<b>Docket Number:</b>	08-AFC-08A
<b>Project Title:</b>	Hydrogen Energy Center Application for Certification Amendment
<b>TN #:</b>	201074
<b>Document Title:</b>	Supplemental Responses to CEC Requests-Carbon Sequestration and Green House Gas Emissions
<b>Description:</b>	N/A
<b>Filer:</b>	URS
<b>Organization:</b>	URS Corporation
<b>Submitter Role:</b>	Applicant Consultant
<b>Submission Date:</b>	10/29/2013 5:16:29 PM
<b>Docketed Date:</b>	10/30/2013

# Supplemental Responses to CEC Requests Regarding Carbon Sequestration and Greenhouse Gas Emissions

Amended Application for Certification  
for  
HYDROGEN ENERGY CALIFORNIA  
(08-AFC-8A)  
Kern County, California

**FIGURE CS-7E-1**

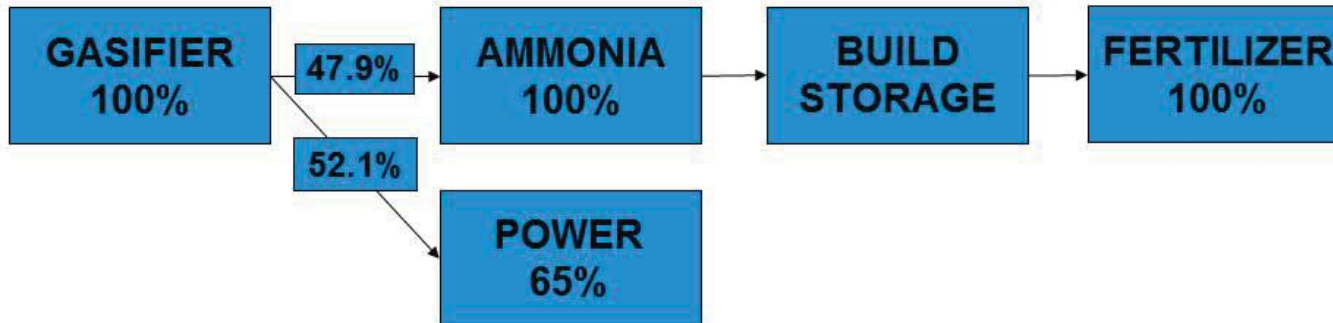
- 1.g. CS-7E – Can you please explain why the PSA off-gas consumption is moving in the opposite direction from the syngas in terms of allocation between the two operating cases?**

To better understand the difference in the two operating modes, on-peak power and off-peak power (or maximum fertilizer/ammonia production), see Figure CS-7E-1, Daily Operation Modes; and Figure CS-7E-2, Daily Operation Cycles. PSA off-gas is a by-product of producing pure hydrogen suitable for the feedstock requirements of the ammonia unit. The PSA off-gas is used beneficially as a fuel for the power block during both peak and off-peak power production. During peak power production, the PSA is operating at 60 percent capacity, and the quantity of off-gas is proportional. During maximum ammonia production (off-peak), the PSA is operating at 100 percent capacity, and the quantity of off-gas is proportional. The quantity of PSA off-gas produced is directly proportional to the amount of ammonia produced, and therefore inversely proportional to the power block output.
